**WARRANTY
BULLETIN**

WB19-02A

DATE :	April 2019	SECTION :	01 ENGINE
EXPIRATION:	April 2021		
SUBJECT :	ALTERNATOR IDLER SUPPORT REPLACEMENT

Revision: A

FIGURE 2

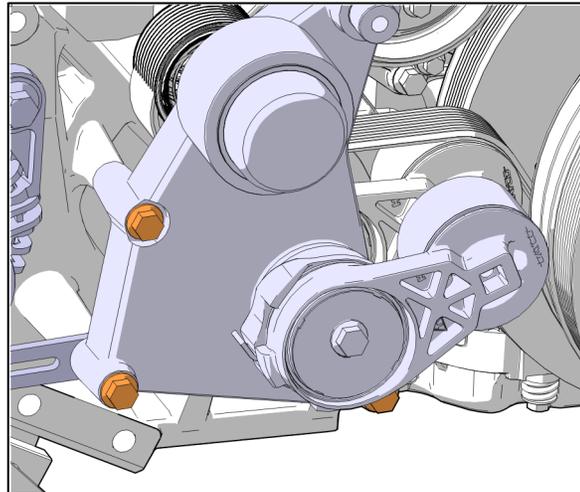
4. Remove the idler support by unscrewing the three screws. Keep hardware for reuse.

Support must be scrapped. It must not be reused on vehicles.

FIGURE 4

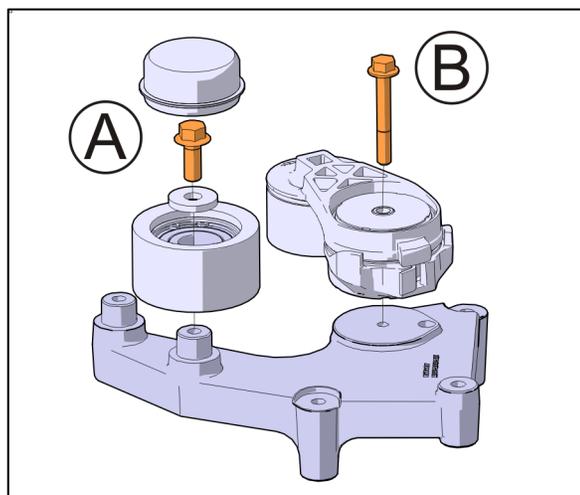
8. Clean mounting surfaces, screws and threaded holes with brake cleaner.
9. Transfer idler **A** to new support.
Assemble with Loctite 243
Tighten screw 5001786 to **59 lb-ft.**
Apply torque seal marks.
10. Transfer belt tensioner **B** to new support.
Assemble with Loctite 243
Tighten screw 5001799 to **48 lb-ft.**
Apply torque seal marks.

FIGURE 5

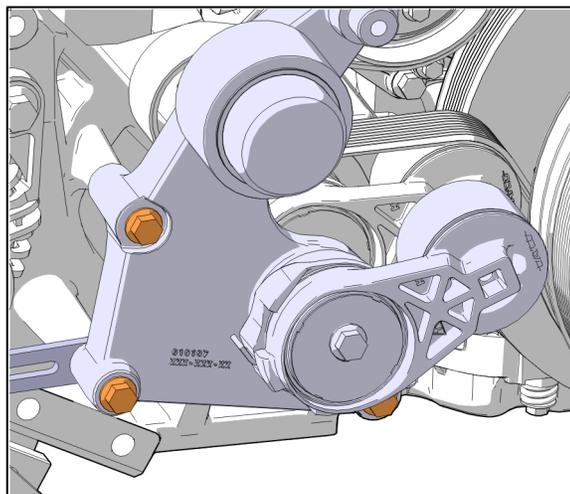
11. Clean mounting holes.
12. Install new idler support.
13. Assemble screws with Loctite 243.
Tighten screw 5001799 to **48 lb-ft**.
Apply torque seal mark.
